Re: Sitestream Traffic Infraction Detector & School Zone Detection System

Hi Felix. Based on our discussion this morning, attached are the revised Traffic Infraction Detector (RLRC) and School Zone Detection System (SDS) plans and supporting documents. Please note that Sitestream will use the same identical pole assemblies for both TID & SDS systems.

DETAIL "E"
COMPONENT PRODUCTS, INC. TRANSFORMER BASE CPI-BAS-1P.

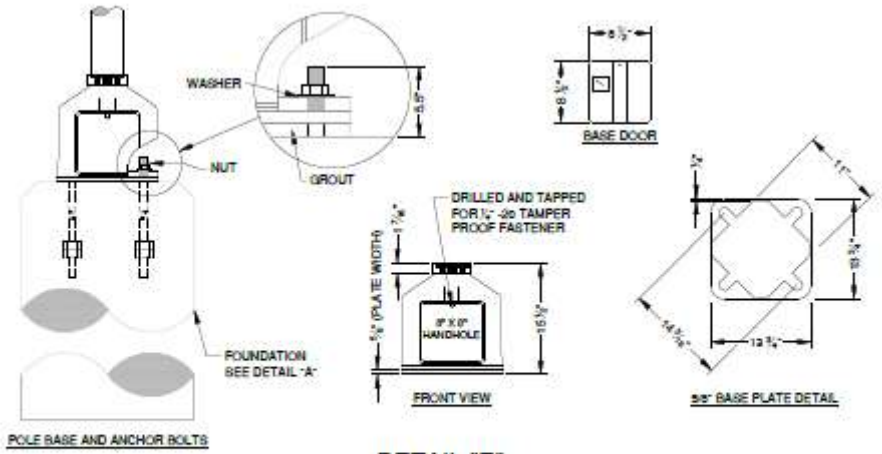
Can you please specify which transformer base from our APL you are planning on using with your poles? It is not clear from the plans, and we can only vouch for the approved ones as being able to work with our devices.

Felix- our plans specify CPI base (see sheet 4 of TID plans). It is the same base that Verra Mobility used for approval. However, PELCO base is also interchangeable. Attached is the FHWA letter for the CPI base. Hope this helps.
